# UNITED STATES PATENT AND TRADEMARK OFFICE

APPLICATION NO.	FILING DATE	FIRST NAMED INVENTOR	ATTORNEY DOCKET NO.	CONFIRMATION NO.
10/663,361	09/16/2003	Stephen P. Dretler	61417.123 US2	1651

<b>Office Action Summary</b>	<b>Application No.</b> 10/663,361	<b>Applicant(s)</b> DRETLE ET AL.	
	<b>Examiner</b> Michael G. Mendoza	<b>Art Unit</b> 3731

**FIG. 1**

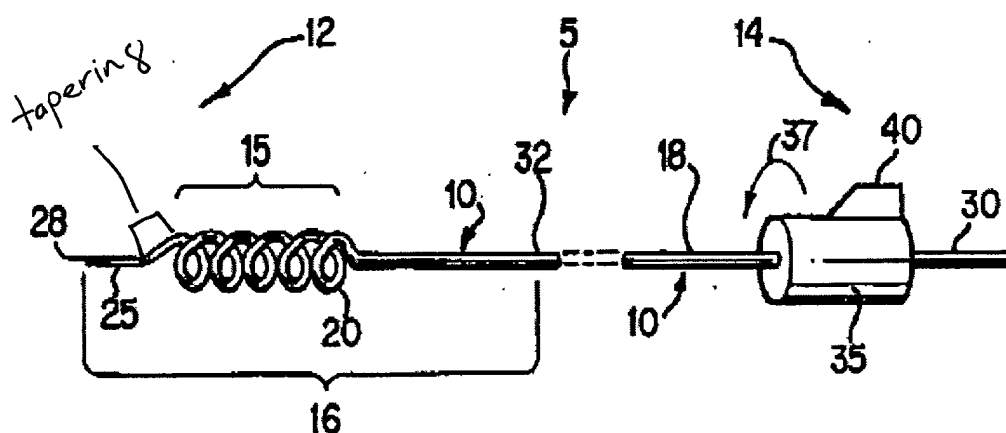
1. Applicant's arguments filed 26 November 2004 have been fully considered but they are not persuasive. The Applicant argues that the device of Chuttani et al. does not taper. As seen in the below drawing, the device does taper.
